MIL-F-50548A (AR)
AMENDMENT 4
18 May 1990
SUPERSEDING
AMENDMENT 3
22 MARCH 1985

MILITARY SPECIFICATION

FUZES, ROCKET, M423 AND M427
LESS BOOSTER AND BOOSTER LEAD

FIGURE 1. Inert Warhead for M151

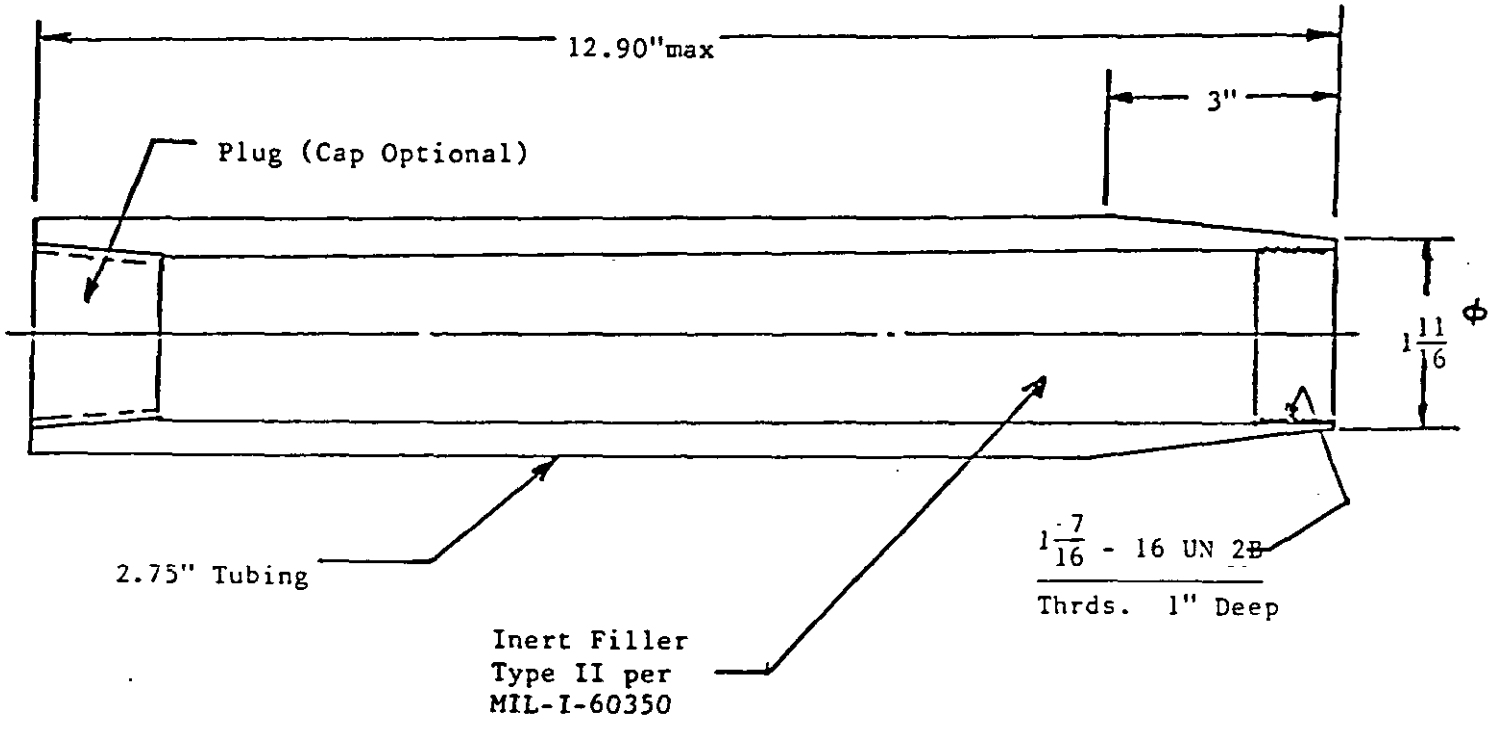
* Add included Figure 1 as page (75a).

"6.4.2 M151 test warhead. The contractor shall furnish inert loaded M151 Test Warhead in accordance with Appendix III for the Five Foot Drop Test and Forty Foot Drop Test."

TOTAL WEIGHT TO BE 8.7 ± .5 LBS.
